**Idaho Department of Environmental Quality
Idaho Falls Regional Office
Sanitary Survey Report
City of Victor PWS# 7410013
September 21, 2005**

A. Purpose of Report

The purpose of this report is to present a sanitary survey review of the water system conducted on August 30, 2005 and to identify any deficient areas that represent a health risk and require immediate correction.

Fig. 5 – Willow well head

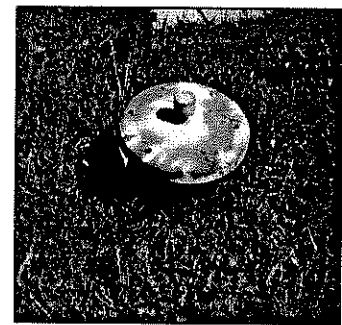
The **Willow Creek well** was constructed in 1993 to a depth of 300 feet. The source is cased the total depth of the well with 16-inch welded steel casing (**Fig 5**). Extending approximately six (6) inches above the ground surface, the casing is perforated from 200 to 300 feet. This source has been surfaced sealed with 40 feet of granite. An acceptable capped well vent is present (see recommendation below). The static water level was measured at 130 feet.

• **FUTURE WELL CASING EXTENSION RECOMMENDATION:**

In accordance with the Idaho Rules for Public Drinking Water Systems IDAPA 58.01.08.550.I.i Casings shall extend a minimum of eighteen (18) inches above the finished ground surface...

It is recommended to extend the well casing of the Willow well to meet the minimum (18) inches above the finished ground surface when future upgrades are done upon the system. Currently bacteria monitoring results do not indicate an immediate need to extend the well casing and therefore extending the casing is a recommendation at this time.
